Project	IEEE 802.16 Broadband Wireless Access Working Group < <u>http://ieee802.org/16</u> >		
Title	Correction to Rx SNR, Rx sensitivity, and Tx Relative Constellation Error for OFDM and OFDMA systems.		
Date Submitted	2005-09-11		
Source(s)	Darcy Poulin [SiGe Semiconductor], Paul Piggin [Cygnus Multimedia Communications], Ran Yaniv [Alvarion], Dov Andelman [Intel]Voice: [613-820-9244 x274] Fax: [Fax Number] 		
Re:	IEEE P80216_Cor1_D4a		
Abstract	Correction to Rx SNR, Rx sensitivity, and Relative Constellation Error for OFDM and OFDMA systems.		
Purpose	The Rx SNR values in 802.16-2004 are incorrect. As a result, relative constellation error (EVM) and Rx sensitivity are also in error. In addition, there are many inconsistencies throughout section 8.3, 8.4, and 12.4 specifying EVM and Rx SNR. This submission attempts to resolve these inconsistencies.		
Notice	This document has been prepared to assist IEEE 802.16. It is offered as a basis for discussion and is not binding on the contributing individual(s) or organization(s). The material in this document is subject to change in form and content after further study. The contributor(s) reserve(s) the right to add, amend or withdraw ma

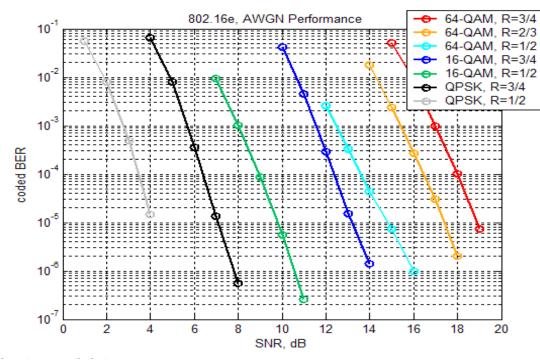
For subscriber stations, we are also proposing that we cap the EVM at -30 dB. Applying a cap at -30 dB means that for the worst case 64QAM-3/4 modulation, the transmitter will degrade the overall SNR by 1.5 dB.

For base stations, we will not put a cap on EVM, so it remains at -31 dB. This will result in a worst case degradation of the SNR of 1.2 dB for 64QAM-3/4. To summarize:

SS EVM = BS SNR + 10 dB. This is capped at -30 dB.

BS EVM = SS SNR + 10 dB
